Z-32-2018

MEMO

SUBJECT: City Council agenda item for December 3, 2019 – Z-32-18

RALEIGH PLANNING COMMISSION CERTIFIED RECOMMENDATION

13. Article 8.4 Streets. Alternate street sections are allowed as shown on Sheet PD-03 and as shown below.

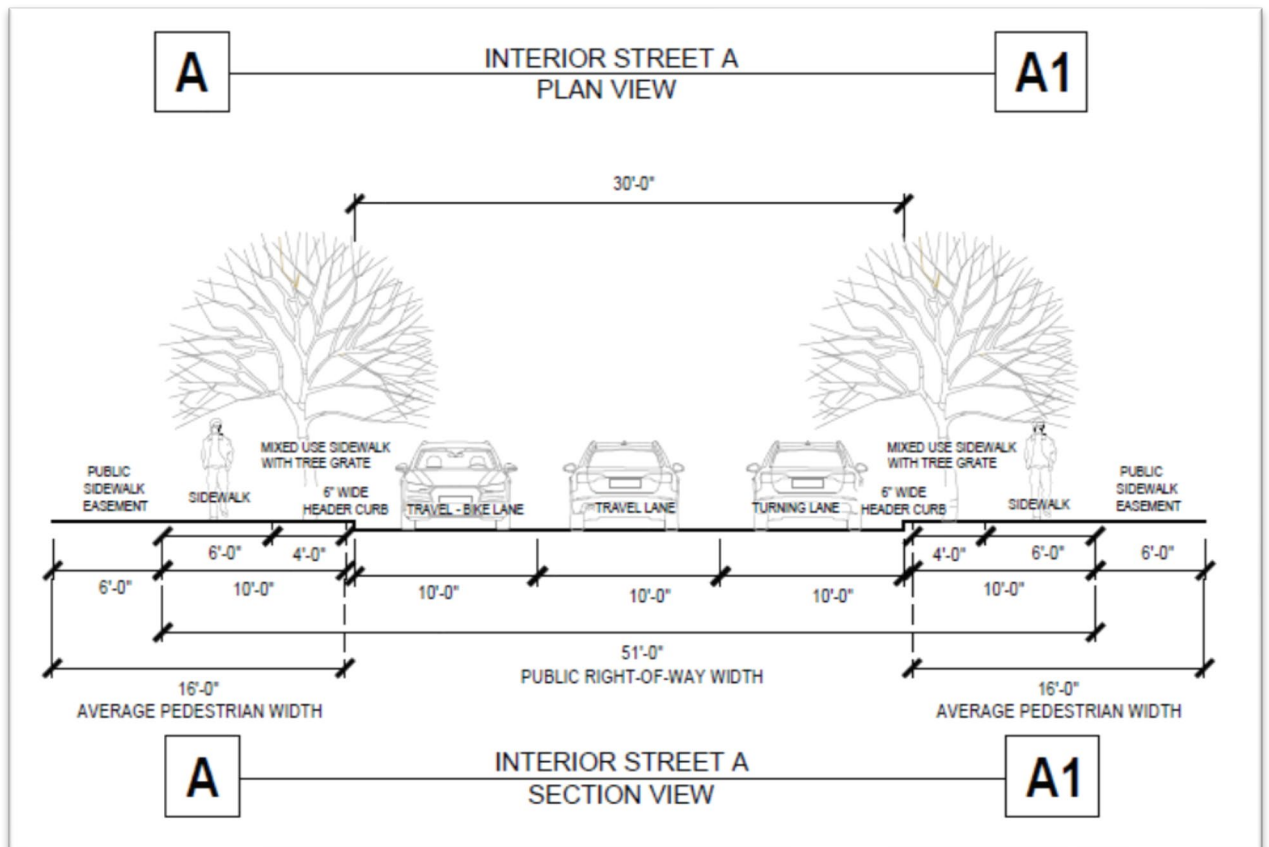
**The application includes an "A" and "B" interior street view, only the A is being shown in this report because they are identical. The full streetscape is included in the report backup.*

Existing code requirements: The existing code requirement is for Main Street, Parallel Parking. Which specifies a right-of-way width of 73', a back-of-curb to back of curb width of 41', a streetscape area of 10', a planting area of 6', parallel parking lane of 8.5' and a travel lane of 12'.

- **The internal streetscape is 16" in width, with a 6' sidewalk, a 4' tree planting area and a 6' public sidewalk easement.**

- The case was revised on October 16, 2019 to resolve the outstanding issue of the plan sheets and the narrative not matching with regards to the streetscape. The proposed sidewalk is wider than the code requirement of 10' and proposes a minimum 16' sidewalk. The PD also provides a sidewalk connection to the code required greenway easement access that connects to the larger greenway network, providing opportunities for pedestrian and bicycle access.

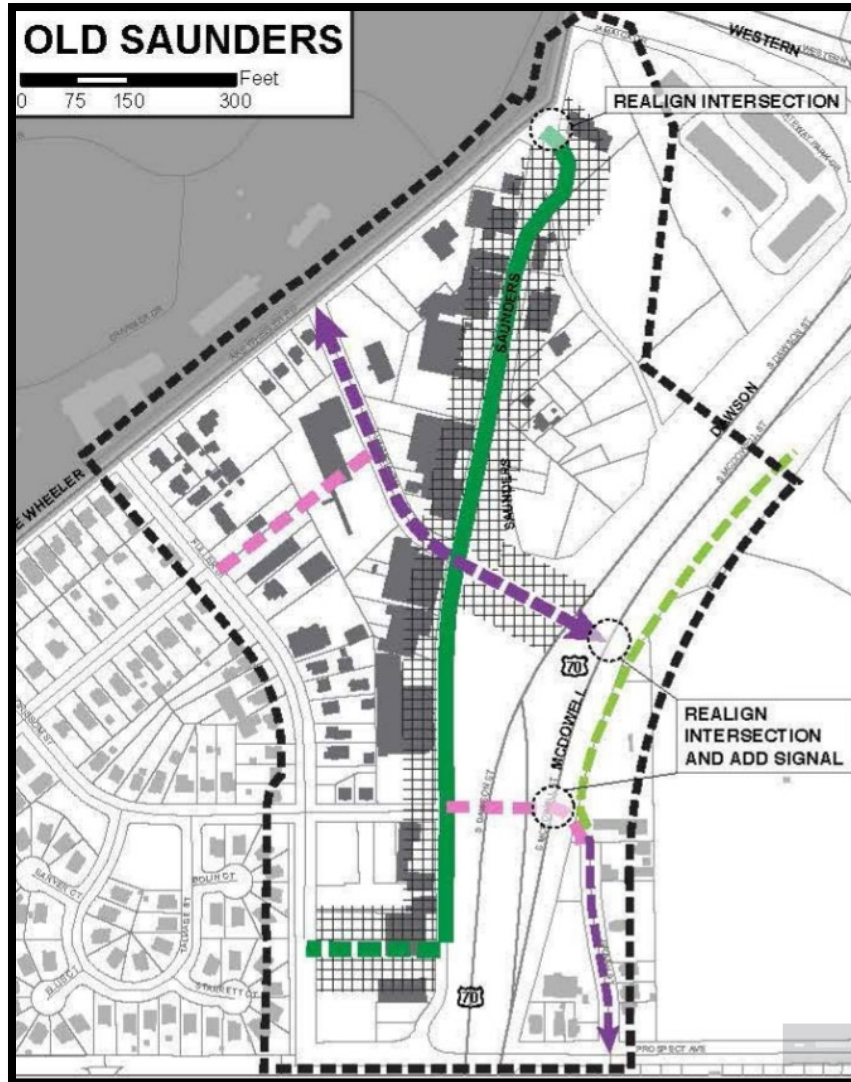
In accordance with UDO section 8.3.2, the maximum allowable block perimeter for Planned Development Zoning districts is 4000 feet. The Master Plan proposes a base zoning district of IX-20. The block perimeter maximum for Mixed Use districts of 5+ stories is 2500 feet. The Master Plan assumes that the Mount Hope Drive ROW will be abandoned. This would require Raleigh City Council Action after staff review and a public hearing. If this is done, the resulting block perimeter for the combined block would be approximately 3470 feet. This block would be bound on the north and east sides by Western Boulevard, the Dawson-McDowell Connector, and an interchange ramp. If this ROW is not abandoned, the existing block perimeter for Z-32-18 is approximately 2020 feet for the southern block formed by South Saunders, the Dawson-McDowell Connector, and the unimproved ROW for Mount Hope Drive. The other block, formed by Western Boulevard, the Dawson-McDowell Connector, and the unimproved ROW for Mount Hope Drive forms a block approximately 2690 feet in perimeter.

The site is located adjacent to urban neighborhoods with small blocks; nearby blocks in Boylan Heights are between 1200 and 2000 feet in perimeter; and most blocks in Fuller Heights are less than 2000 feet in perimeter. The PD includes a new proposed public street loop connecting at both ends to South Saunders Street. This would create a new block with a perimeter of approximately 1,200 feet but would not improve the overall perimeter of the larger block.

As proposed, this Planned Development District exempts the site from block perimeter standards and does not provide any form of public access (vehicle or non-motorized) between the west side of the site and the frontage on Dawson Street to match or approximate the nearby character. It is expected that fire code requirements will require points of emergency vehicle access around the proposed buildings. These emergency accessways should be co-located with pedestrian passages, utility easements, new public streets, and/or parking garage access driveways to provide integration of the proposed planned development with the surrounding neighborhoods.
